ADDENDUM No. 1

Bid No. 21-22/37 – Building D-510 Janitorial Services

Revised Maps – 2nd Floor Plan

PRINT DATE: 03-01-19 1:53:39 C:\pwworking\vol\peretz\p077609\A17-0004A-2110.dwg Printed by PerezBB

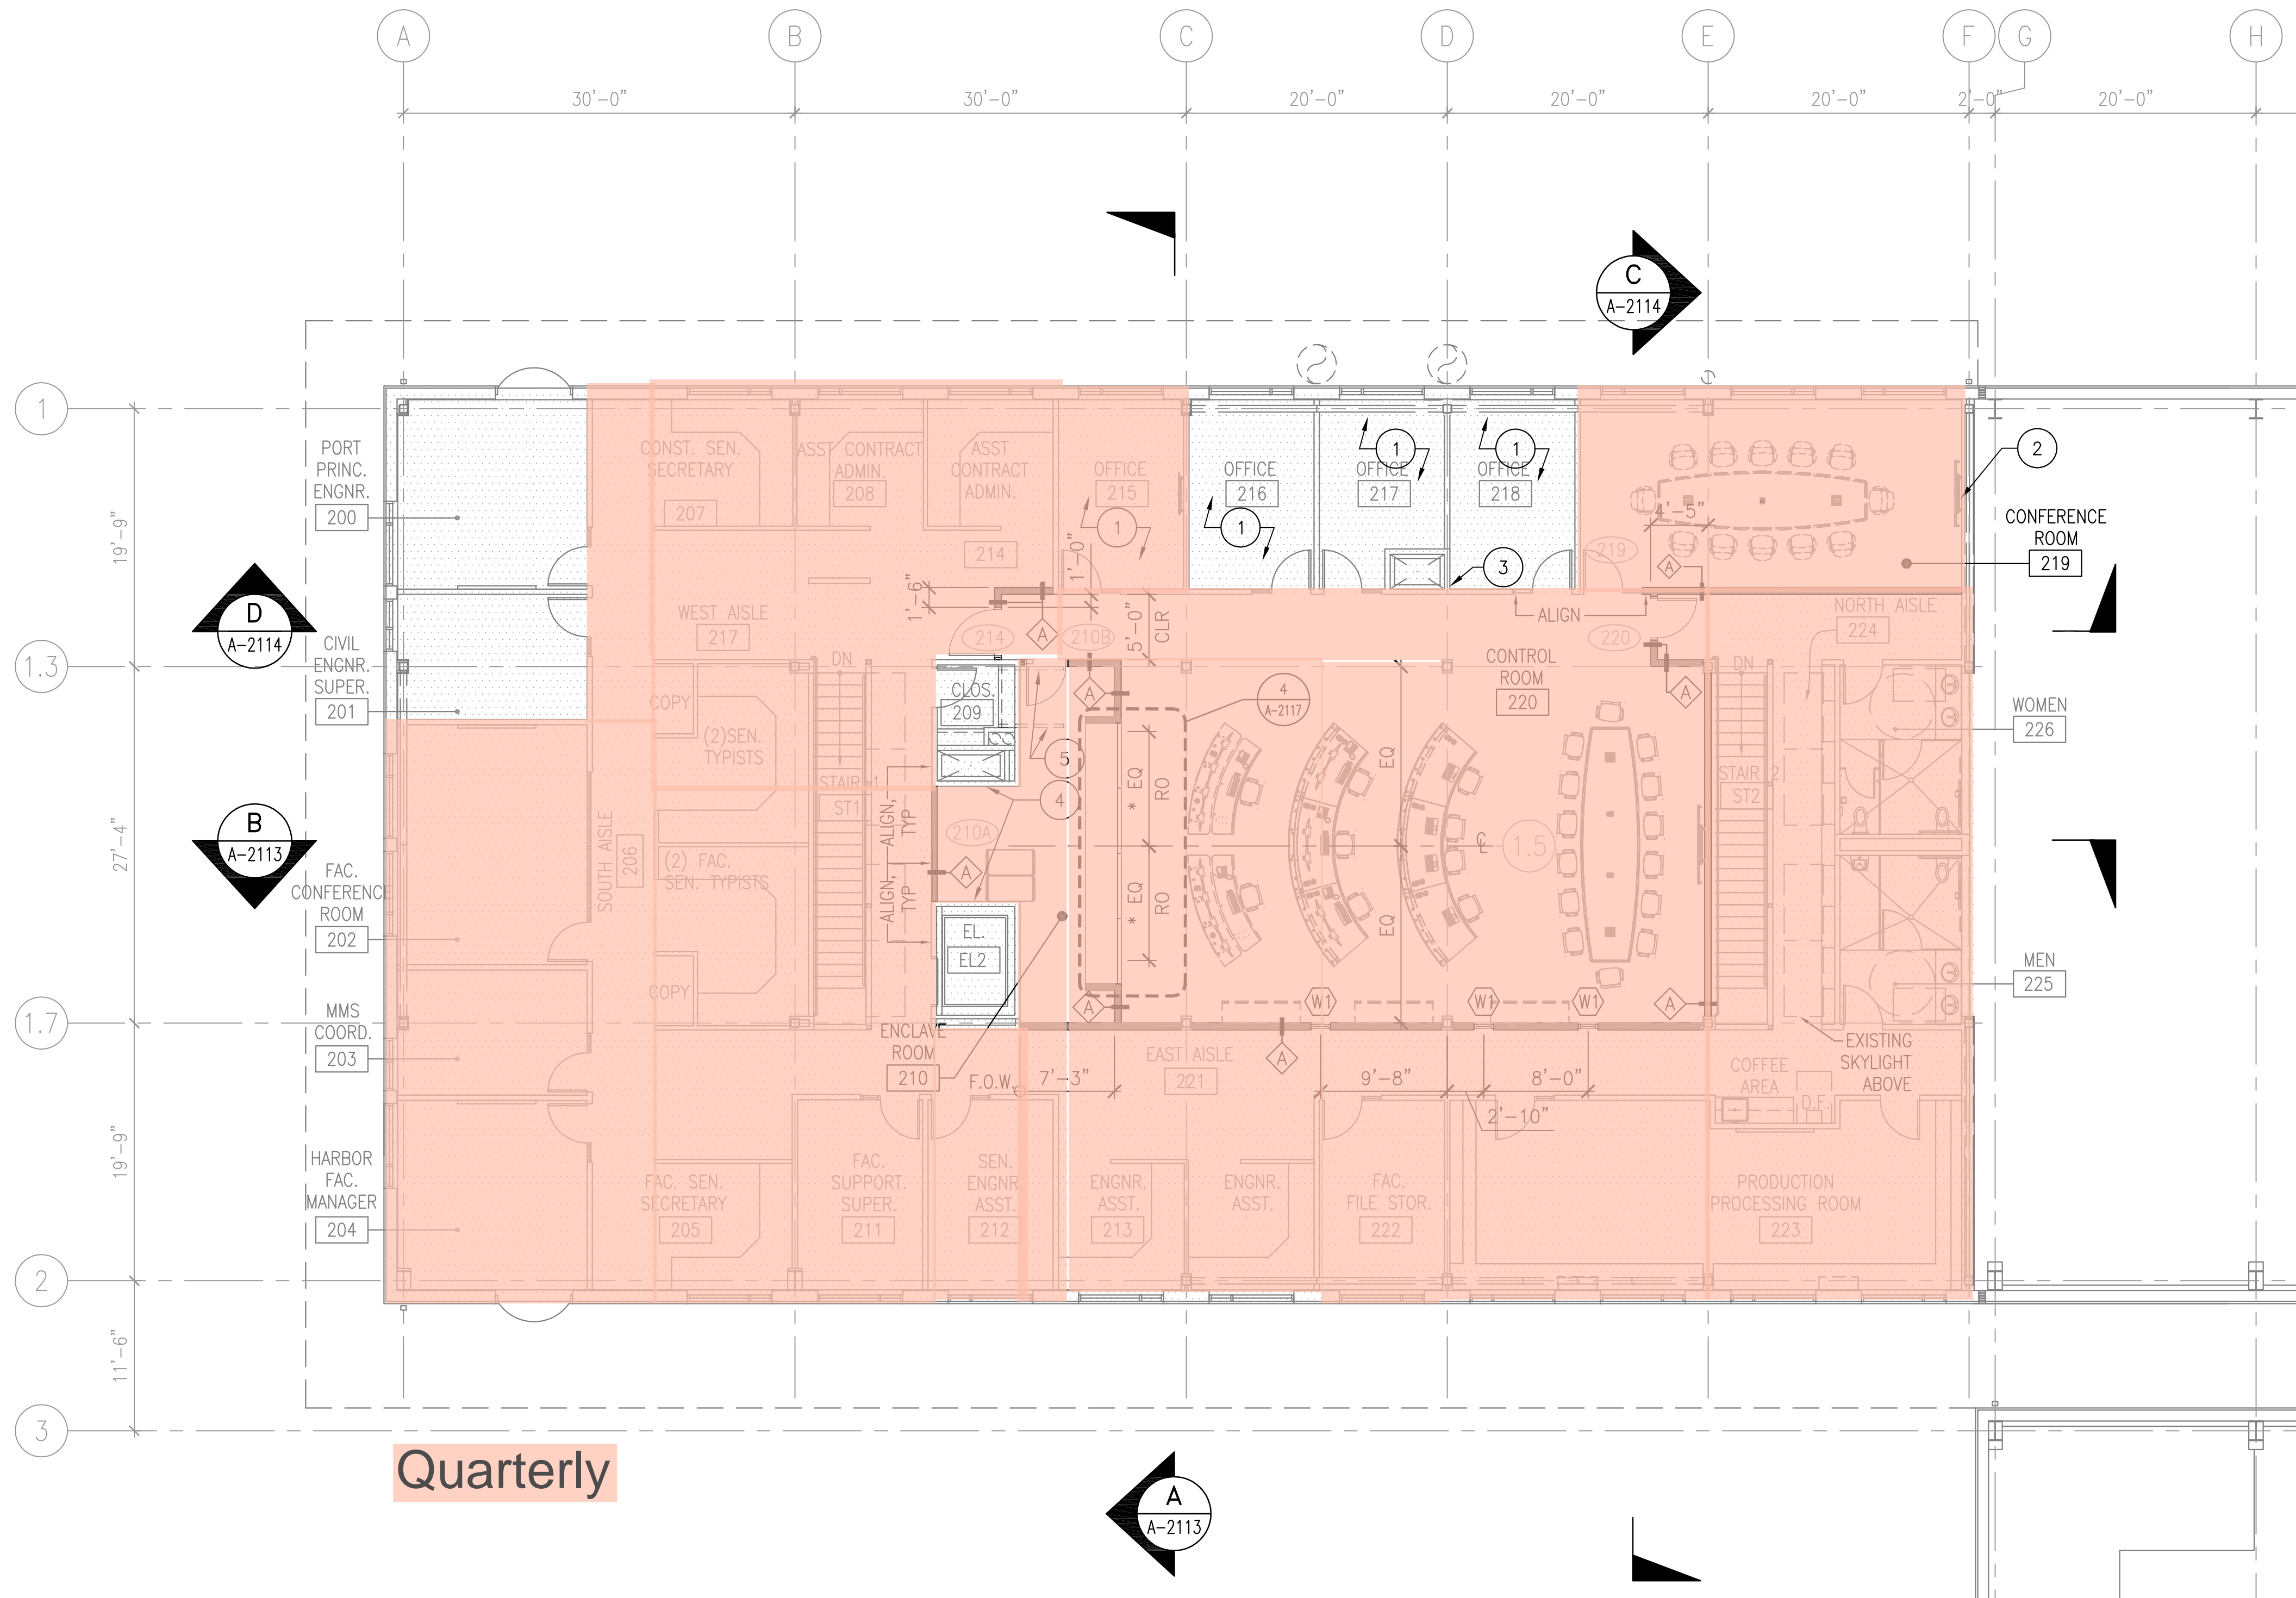
1. Port of Oakland has updated 2nd Floor maps titled “ADMINISTRATION SECOND FLOOR PLAN – AREA 1” with the revised “HFC BUILDING – 2ND FLOOR PLAN” maps for Daily and Weekly; Monthly, and Quarterly, see Attachment 1 of this Addendum for revised floor maps.
